MEMORANDUM

SUBJECT: Final Decision CPV Towantic, LLC's 805 MW combined cycle plant, permit numbers 144-0023 through 144-0027

Oxford Zoning Designations

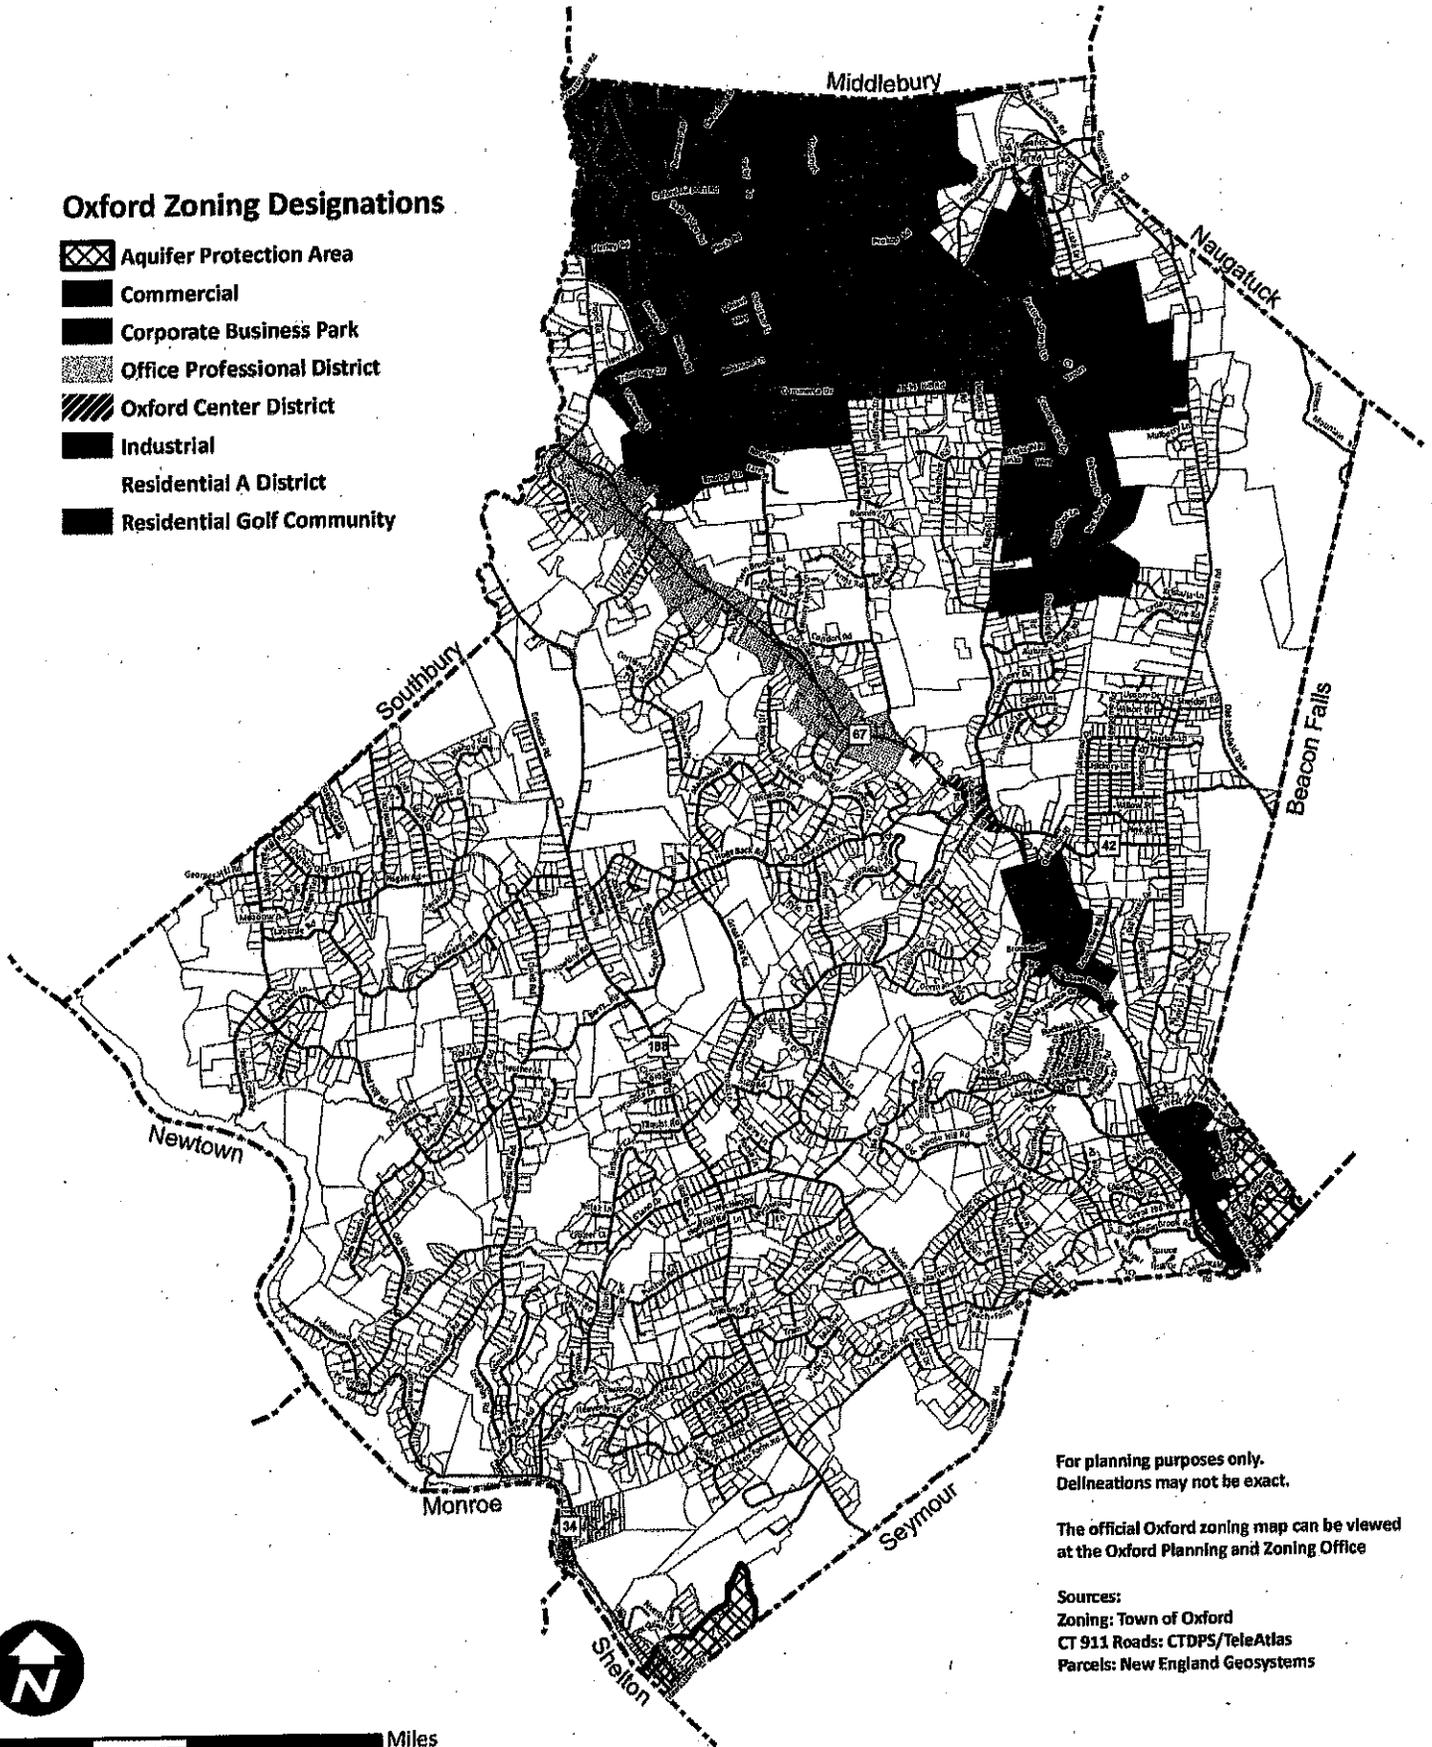
12. Several commenters requested that DEEP staff tour the proposed site.

State Senator Joan Hartley – 15th District specifically requested in a letter to Commissioner Klee, dated September 18, 2015 that DEEP staff tour the proposed site.

Jaimeson Sinclair (Assistant Director) and James Grillo (APCE) of the Bureau of Air Management toured the site on October 1, 2015 with CPV representative Andrew Bazinet. Additionally, DEEP staff drove through many of the local roads and neighborhoods surrounding the proposed plant without any CPV representatives being present. These included Prokop Road, Towantic Hill Road, Long Meadow Road, Country Club Road, and Putting Green Lane.

The attached zoning maps show the CPV property and the abutting properties. All of the abutting properties are either owned by the Town of Oxford or Algonquin Gas Transmission LLC. The property owner for site 8-9A is listed as Woodruff Hill View, LLC but CPV has stated that they now own this parcel.
